NEW FEATURES

■ EXTERIOR

1. Front Design

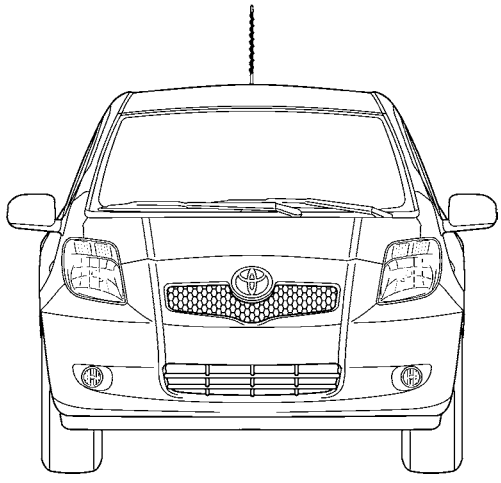
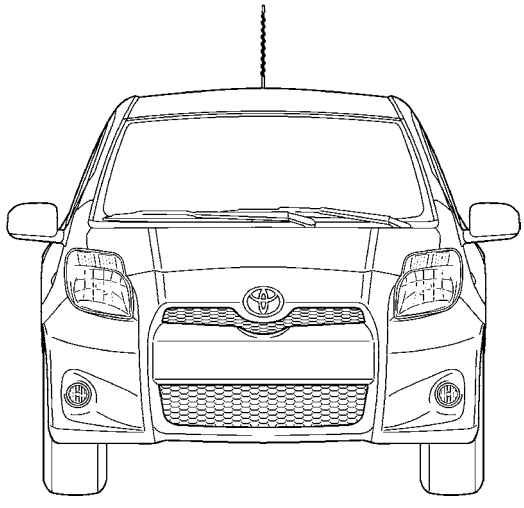
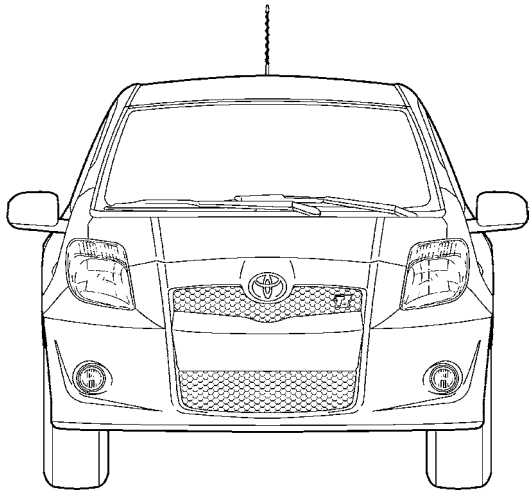
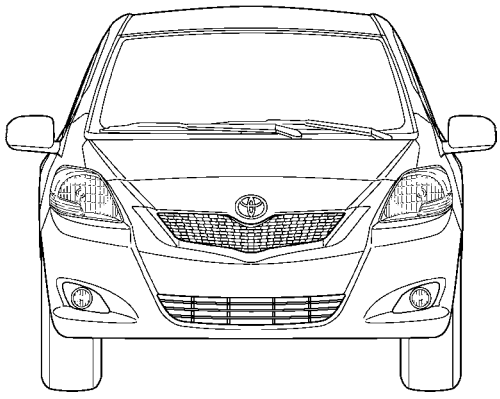
- The front design of the hatchback and sedan models has been changed.
- The design of the front bumper, radiator grille, and headlights of the hatchback models has been changed, achieving a sophisticated, dynamic, and sporty feel.
- A silver radiator grille is provided on the models for G.C.C. countries with the 1NZ-FE engine.

New Yaris Sedan Model

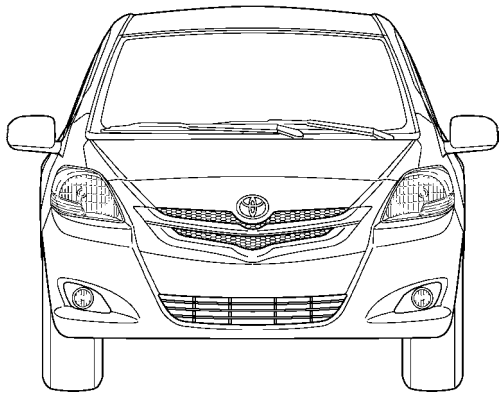
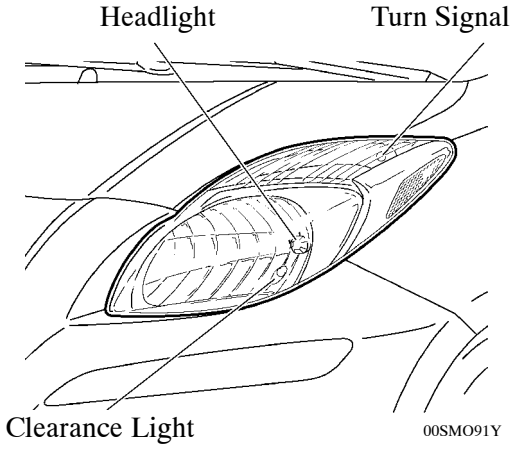
- The design of the radiator grille on the sedan models has been changed, achieving a design that emphasizes quality and sportiness.

2. Rear Design

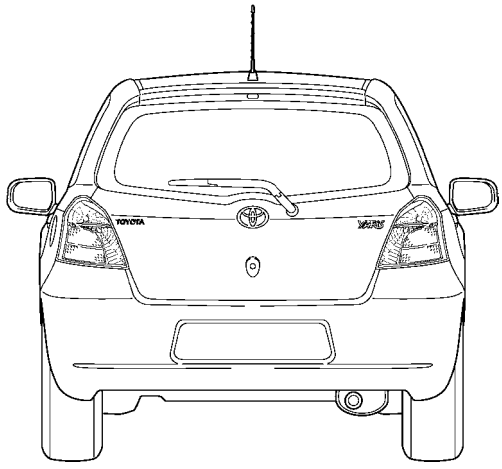
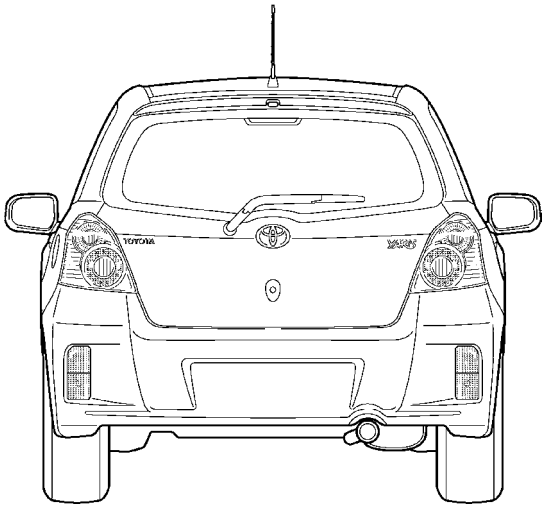
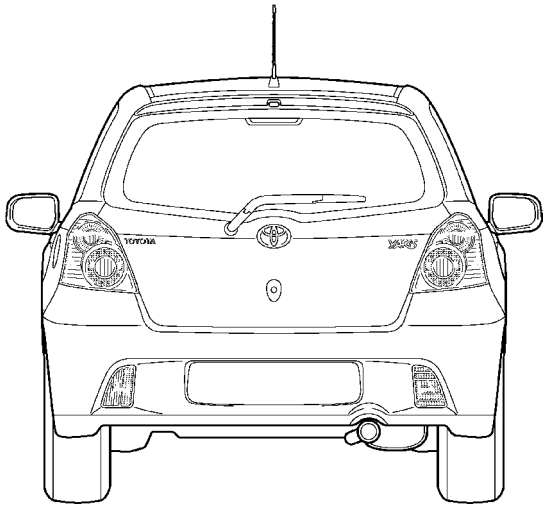
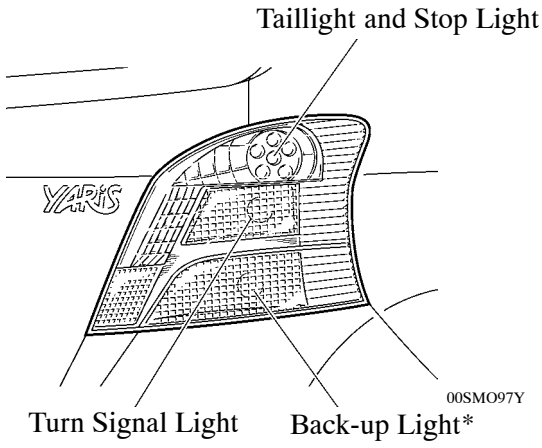
The rear design of the hatchback models has been changed.

- The design of the rear combination lights and rear bumper on the hatchback models has been changed. The pleasing appearance that extends from the bumper to the combination lights achieves a wide-bodied, sporty feel.
- The design of the rear bumper has been changed and a bumper-mounted rear fog light is provided as standard equipment on the TS grade of the hatchback models.

▶ Rear Combination Light ◀

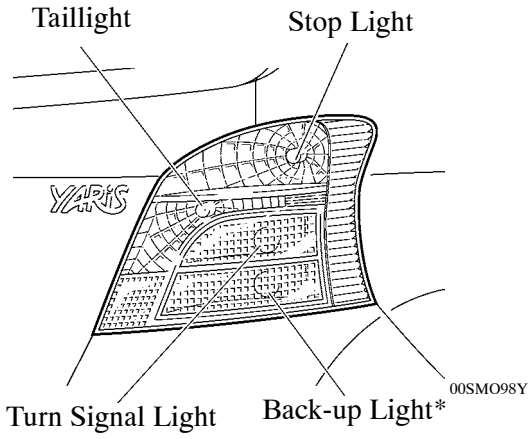
*: A rear fog light takes the place of either one of the back-up lights on the models equipped with the rear fog light.

3. Side Design

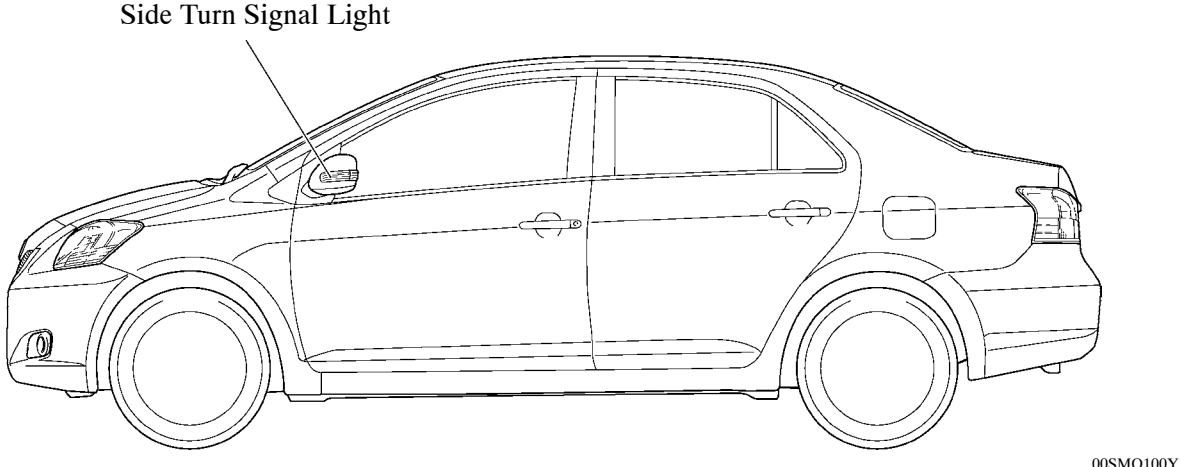
A side turn signal light on the outside rear view mirror is provided as optional equipment on the sedan models for Australia and RHD sedan models for general countries.
